30-039-07890 SAN JUAN 30 6 UNIT #067

HILCORP ENERGY COMPANY

HILCORP ENERGY COMPANY
SAN JUAN 30-6 UNIT 67
TA or P&A NOI

Re: MIT for Temporary Abandonment with contingent Permanent Abandonment

SAN JUAN 30-6 UNIT 67 - PROPOSED TA WELLBORE SCHEMATIC

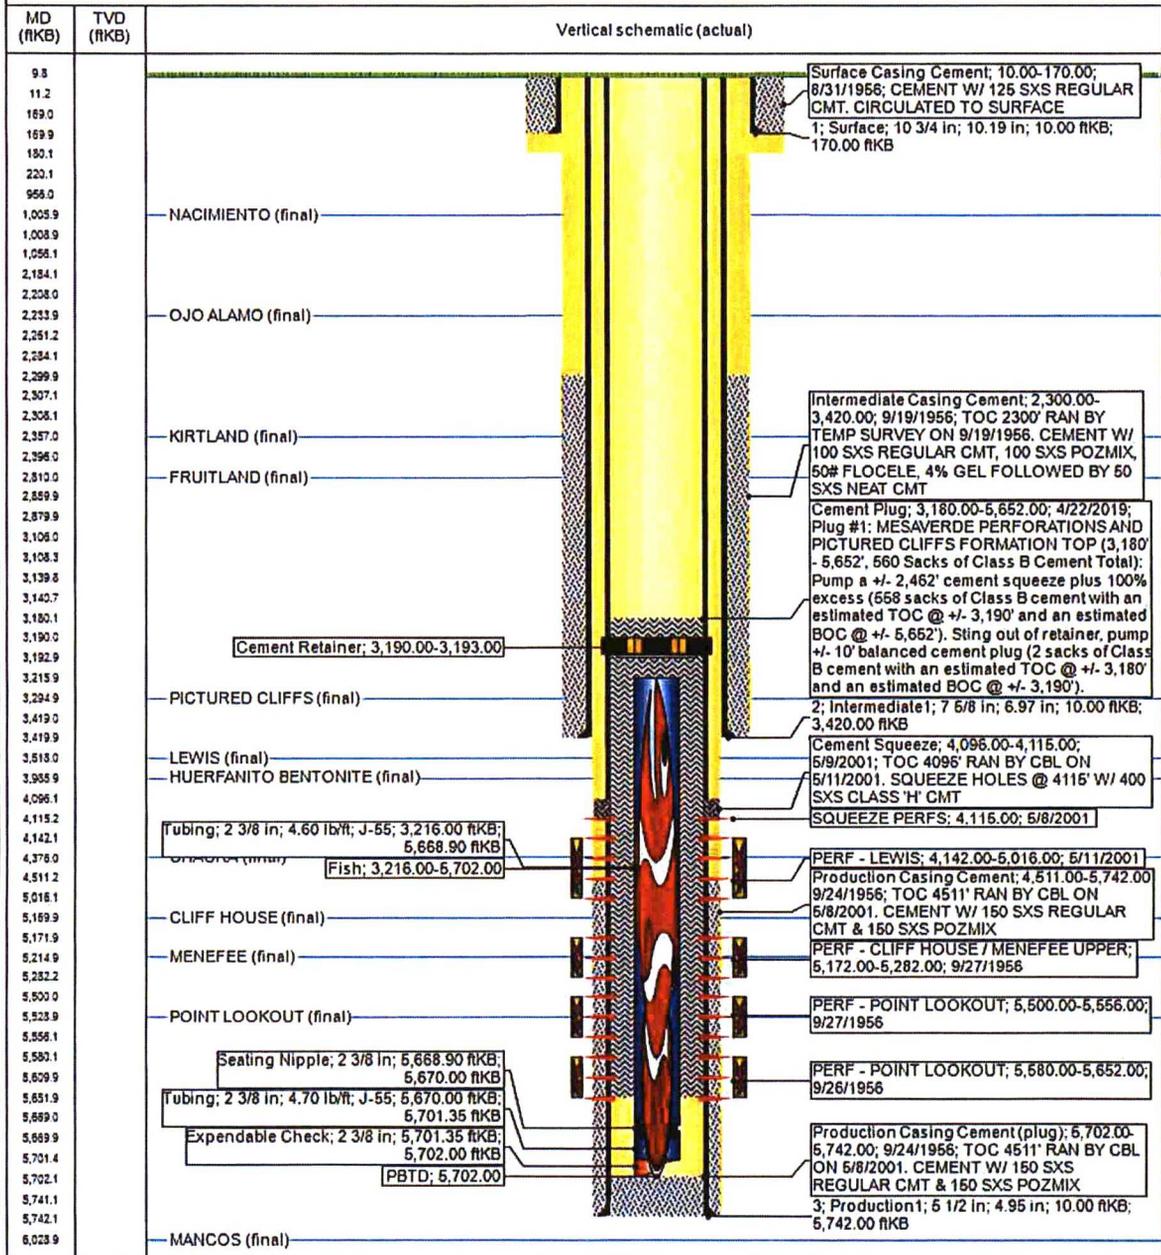
3. The following modifications to your program are required:
 - 3a. Plug #1: After stringing out of CR place 50' of cement with TOC at 3,140' MD.
3. If the MIT fails, identify casing leak location within 50' and contact Joe Killins at BLM to discuss path forward for possible repair and re-test. All plugging operations following MIT are dependent upon subsequent approval after review with BLM and NMOCD.

SAN JUAN 30-6 UNIT 67 - PROPOSED P&A WELLBORE SCHEMATIC

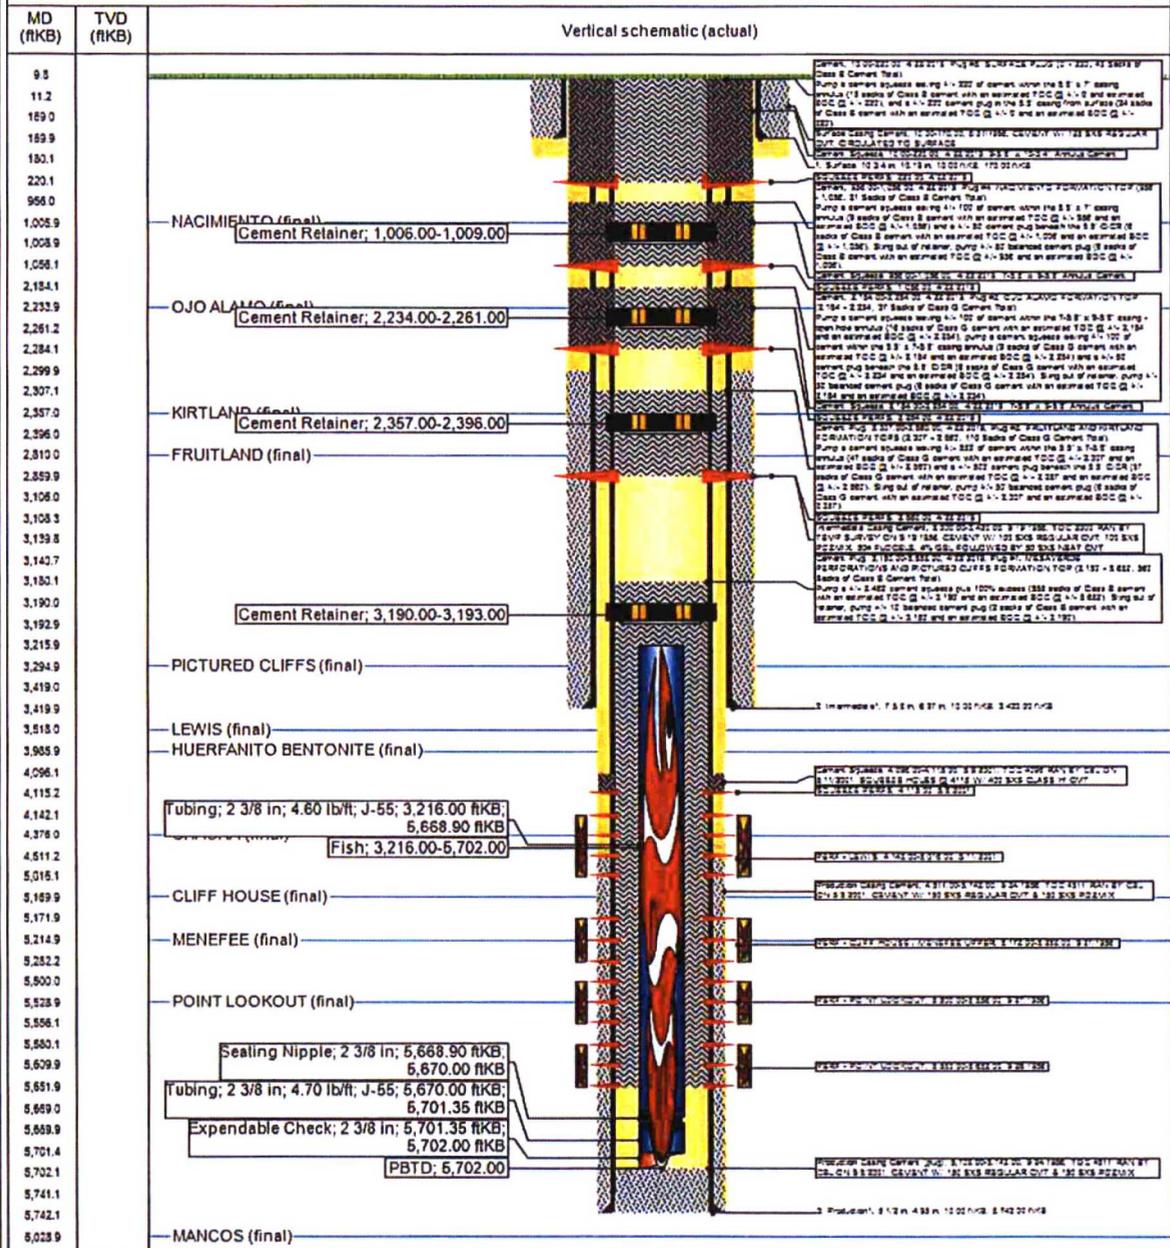
- Notify NMOCD 24hrs prior to beginning operations.
- Extend Plug #2: 2,920-2,307. OCD Fruitland top: 2,870'.
